From: Alex Murray
Sent: Wednesday, December 12, 2007 3:45 PM
To: Frank Gillespie; Allen Croff; Michael Ryan
Subject: FYI - MOX Facility - Waste Management and DPV/DPO
Attachments: MOX-ACRS-2004-Safety-Concerns.ppt; MOX-DPO-Waste-Management.wpd

Safety Concerns and Differing Viewpoints and Opinions on MOX

SUBJECT: AUTHORIZATION FOR PUBLIC RELEASE -
DIFFERING PROFESSIONAL VIEW ON WASTE MANAGEMENT AT
THE PROPOSED MIXED OXIDE (MOX) FUEL FABRICATION FACILITY
DOCKET NUMBER: 070-03098

SUBJECT: DIFFERING PROFESSIONAL VIEW ON WASTE MANAGEMENT AT
THE PROPOSED MIXED OXIDE (MOX) FUEL FABRICATION FACILITY
DOCKET NUMBER: 070-03098

CS-01: Red Oil

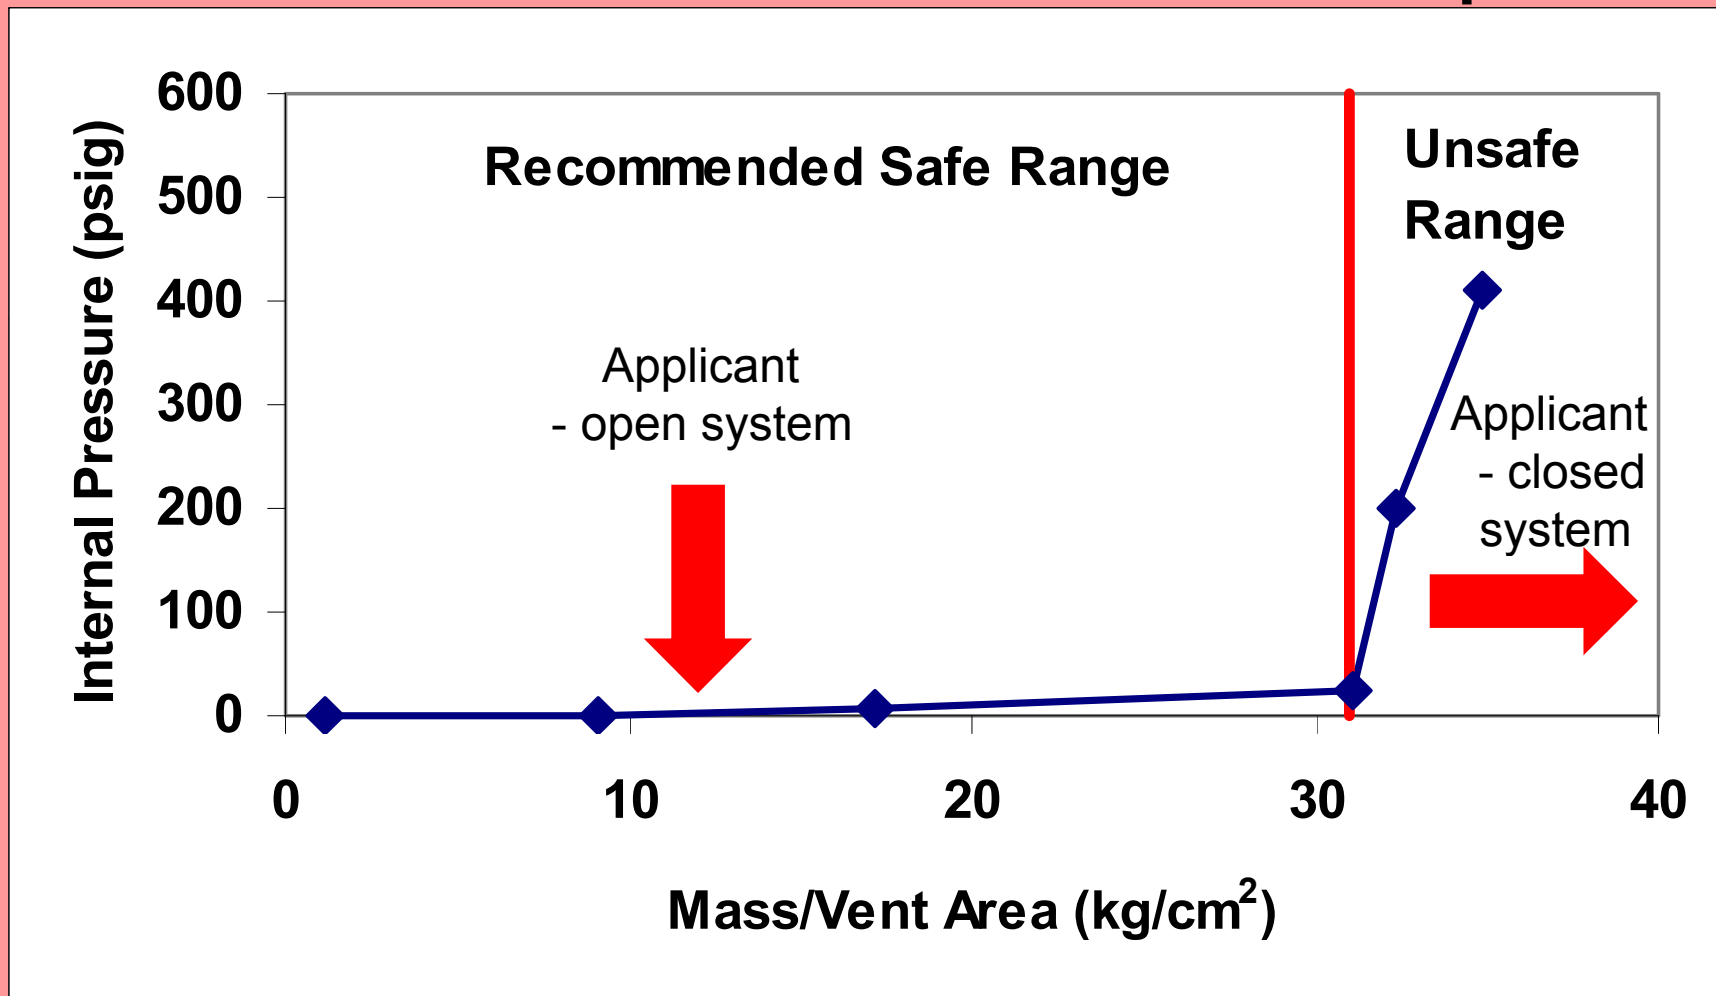
Pressure Vent Relationship

- Approach for closed systems does not provide adequate assurances of safety:
 - Corresponds to 1 control parameter (T)
 - Common mode failure – heat transfer and vent
 - Inadequate margin
 - Uncertainties not adequately considered
 - High aspect ratio design will likely result in higher pressures and temperatures, and phase separation
 - No assurance quench system and 125 C limit will prevent red oil reactions
- No assurance approach can meet Part 70 requirements for a Construction Permit

- Impose DOE/DNFSB RAGAGEP as permit condition
- Give applicant the opportunity to provide assurances about their strategy in the license application

Figure 28 Murphy-Campe / ARCON concentration ratios by observed concentration
(based upon data from 7 reactor sites in NUREG/CR-6331 on ARCON96)

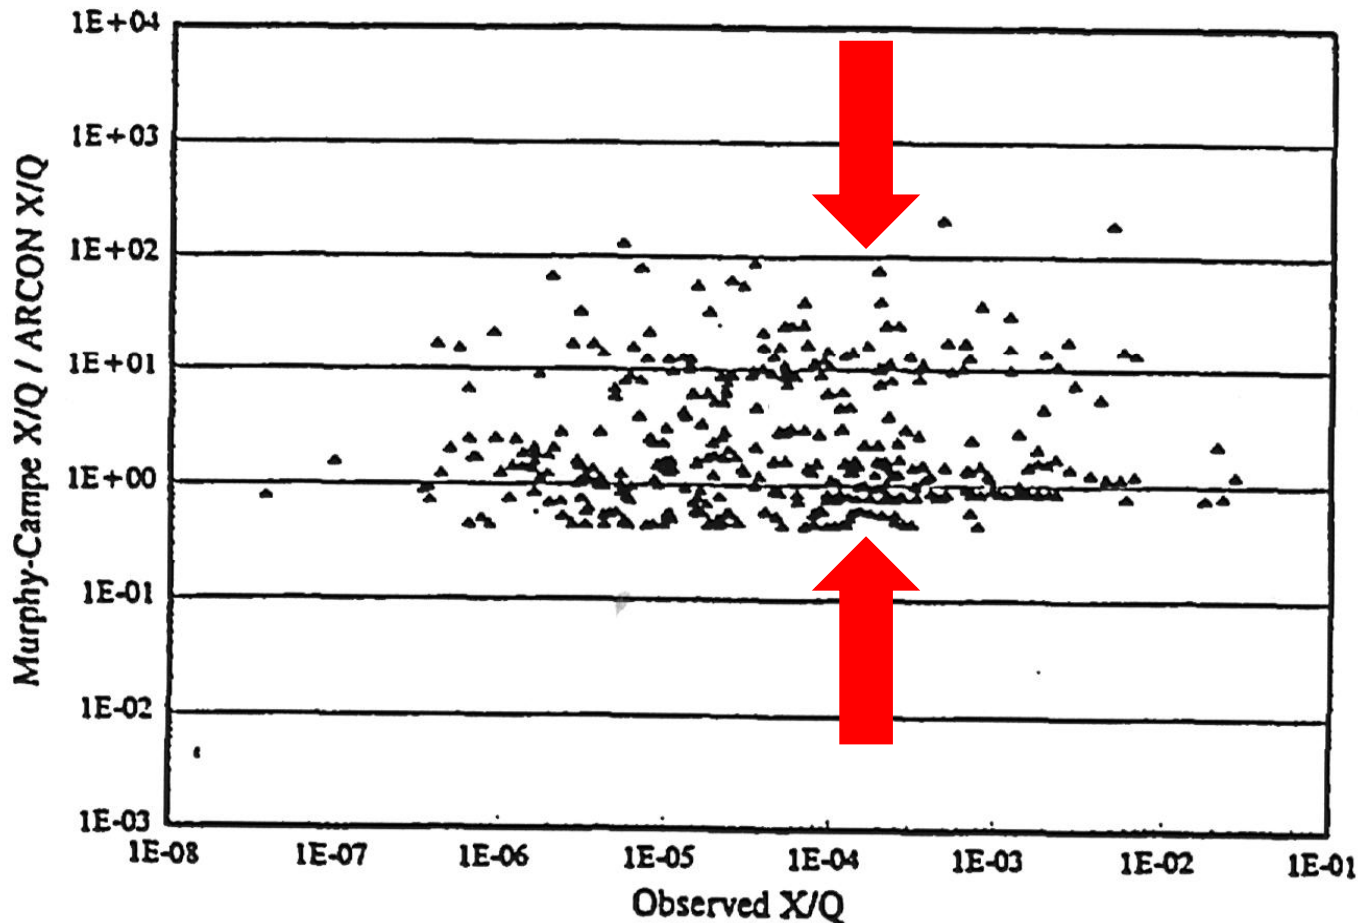
**Applicant
Using
Circa 3E-4**

**Which value
to use?**
